STORM WATER SEWER TO SERVE
QUIKTRIP 8th ADDITION
STORE #315 at KELLOGG & MAIZE
Private Project Number
1090 PPS (607861)
CITY OF WICHITA, KANSAS

RECORD DRAWINGS

STORM WATER SEWER TO SERVE
QUIKTRIP #315
KELLOGG & MAIZE

PROJECT NUMBER	SHEET
1090 PPS (607861)	2R OF 6

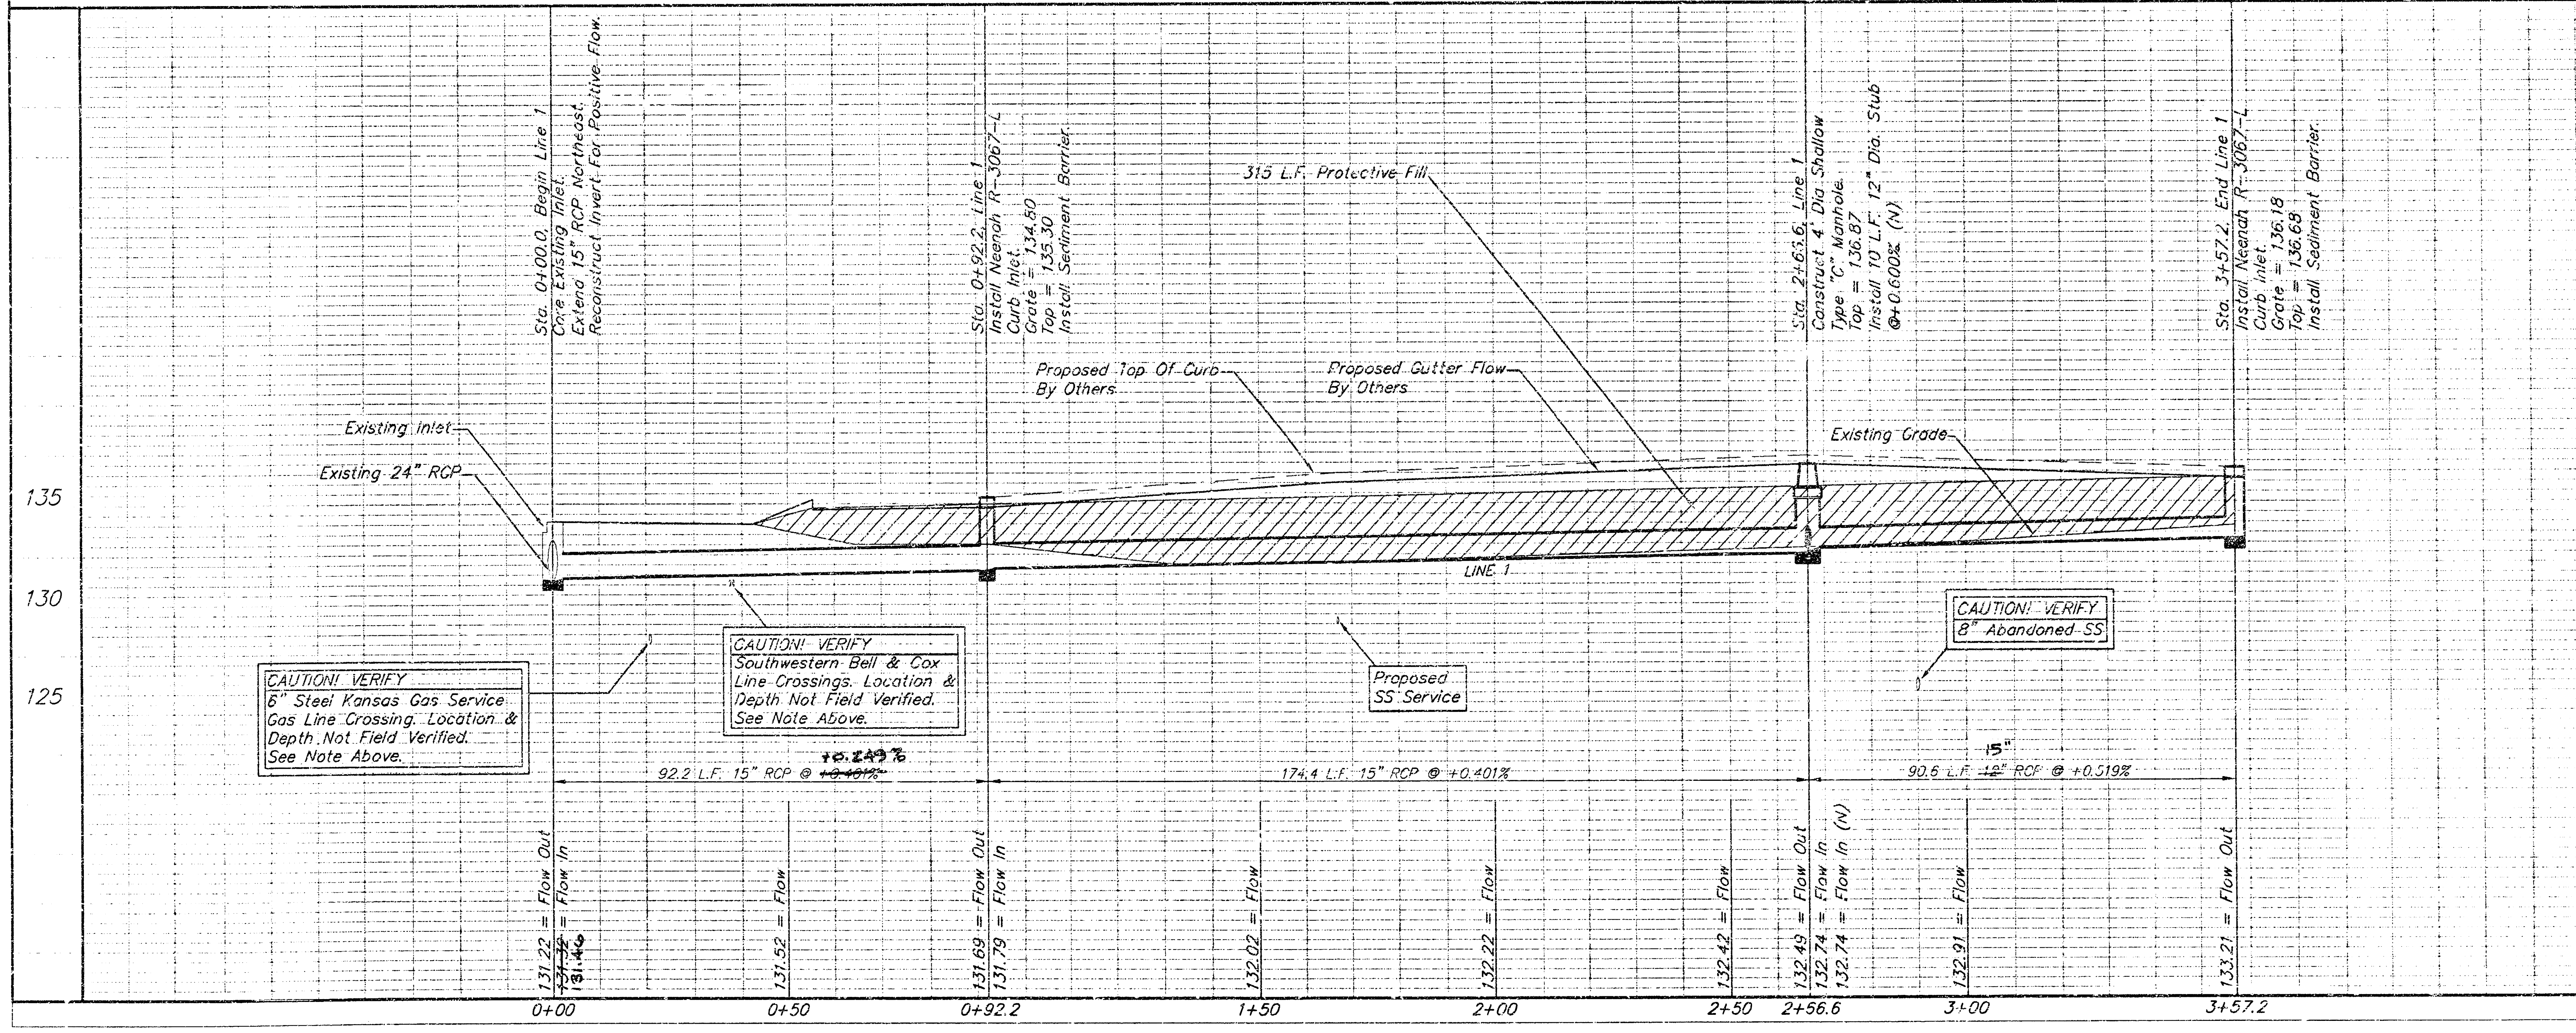
92.2 L.F. 15" RCP @ ~~+0.401%~~ +0.249%
174.4 L.F. 15" RCP @ +0.401%
90.6 L.F. ~~12"~~ 15" RCP @ +0.519%
131.22 = Flow Out
~~131.32~~ 131.46 = Flow In
131.52 = Flow

REVISED 3/25/04
REVISED 4/1/04

PROJECT NUMBER				SHEET
1090 PPS (607861)				3R OF 6
DESIGN LU	DRAWN LU	APPROVED LU	DATE 3/04	SCALE NOTED

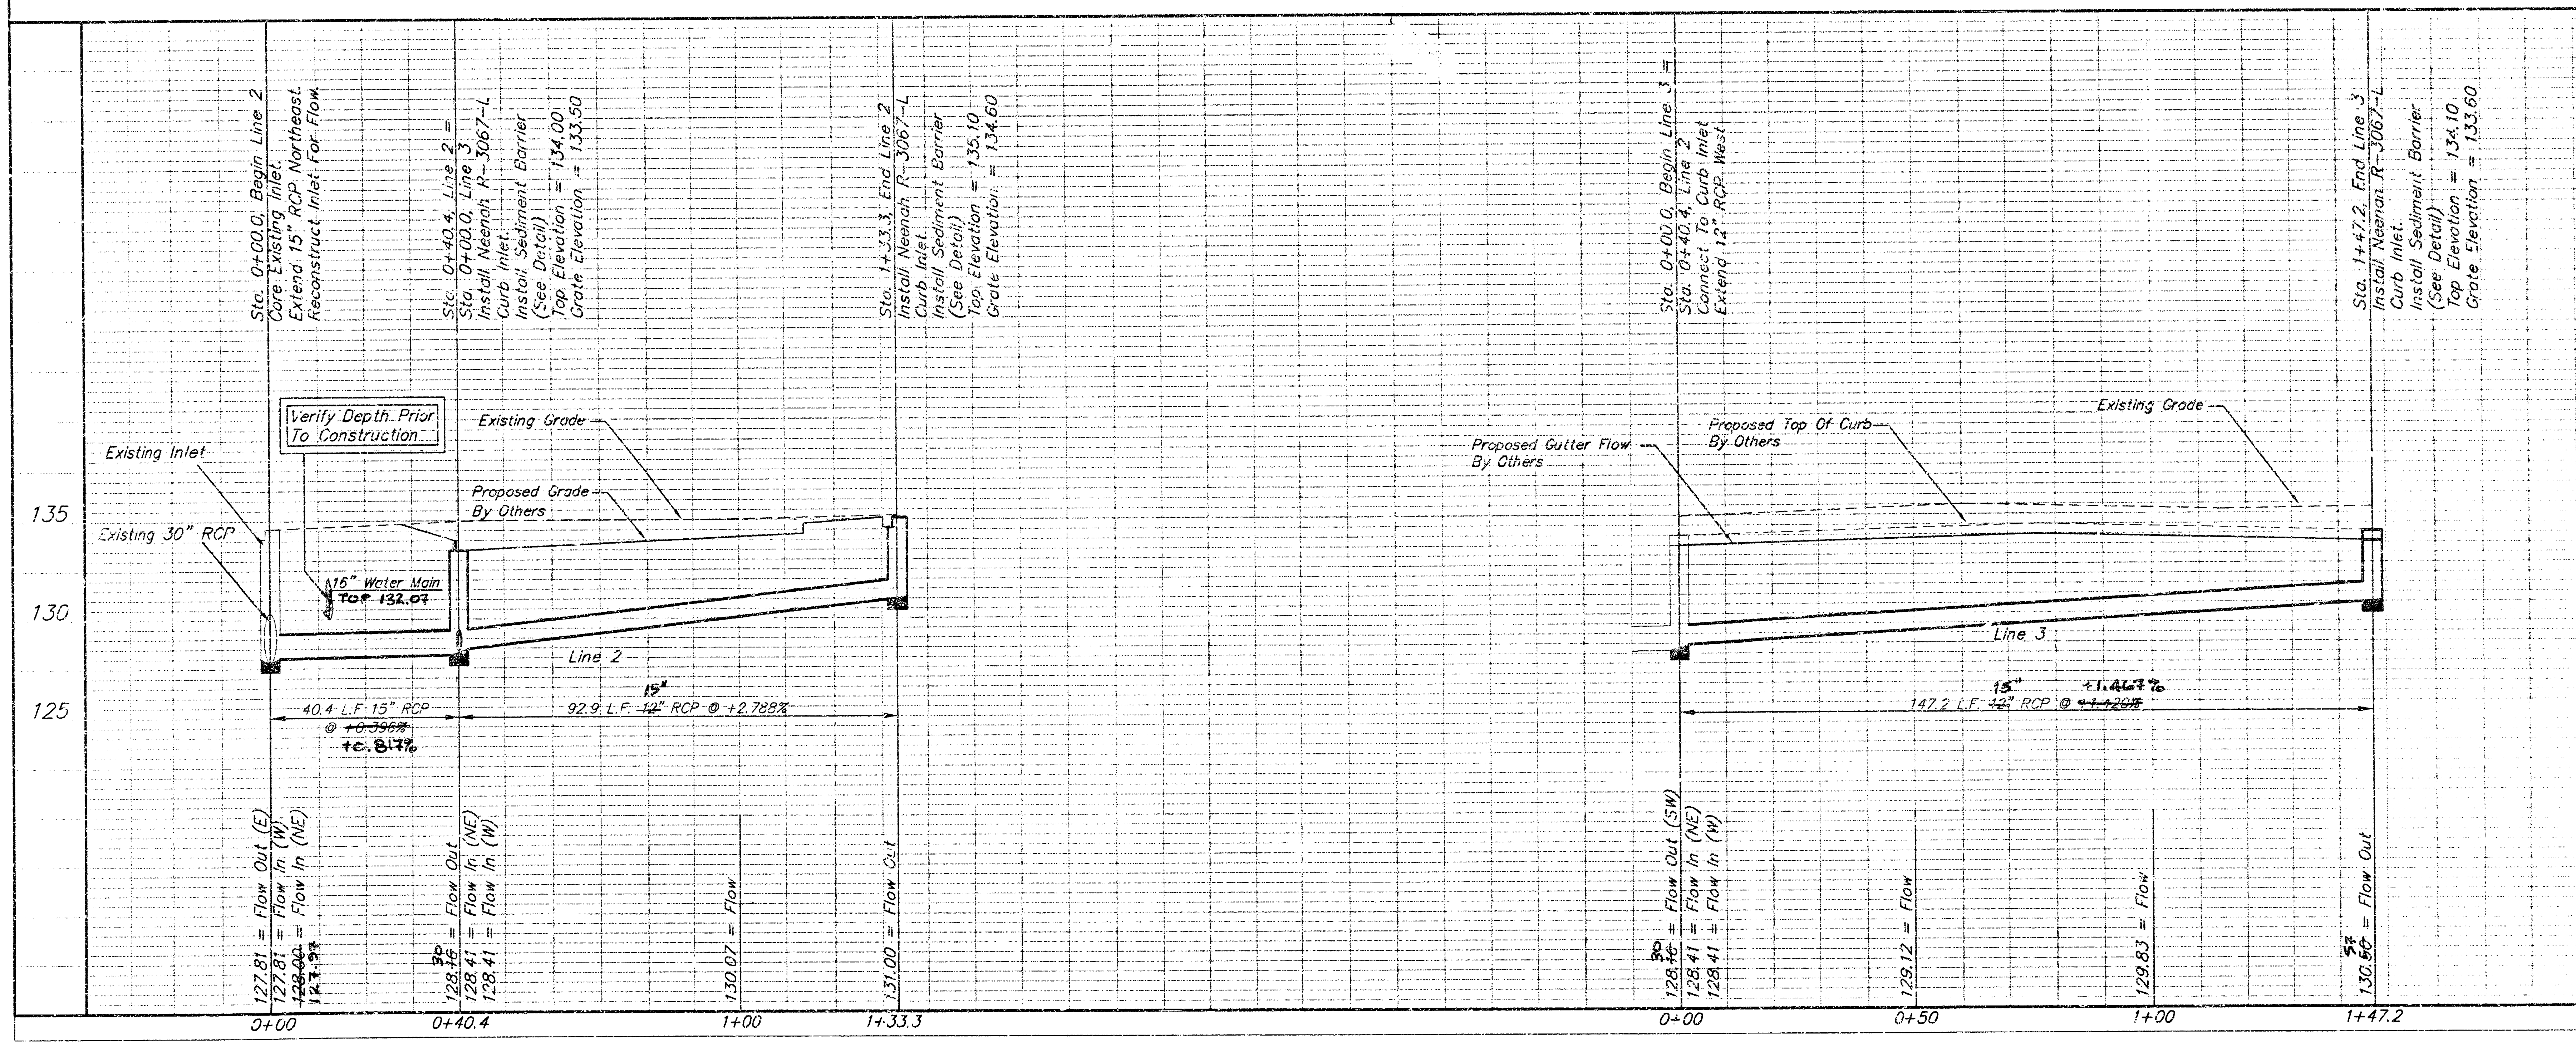
40.4 L.F. 15" RCP
@ ~~+0.396%~~ +0.817%
15"
92.9 L.F. ~~12"~~ RCP @ +2.788%
15" +1.467%
147.2 L.F. ~~12"~~ RCP @ ~~+1.429%~~
127.81 = Flow Out (E)
127.81 = Flow In (W)
~~128.00~~ 127.97 = Flow In (NE)
~~128.16~~ 30 = Flow Out

128.41 = Flow In (NE)
128.41 = Flow In (W)
130.07 = Flow
131.00 = Flow Out
~~128.16~~ 30 = Flow Out (SW)
128.41 = Flow In (NE)
128.41 = Flow In (W)
129.12 = Flow

129.83 = Flow
~~130.50~~ 57 = Flow Out
0+00
0+40.4
1+00
1+33.3
0+00
0+50
1+00
1+47.2

REVISED 3/26/04
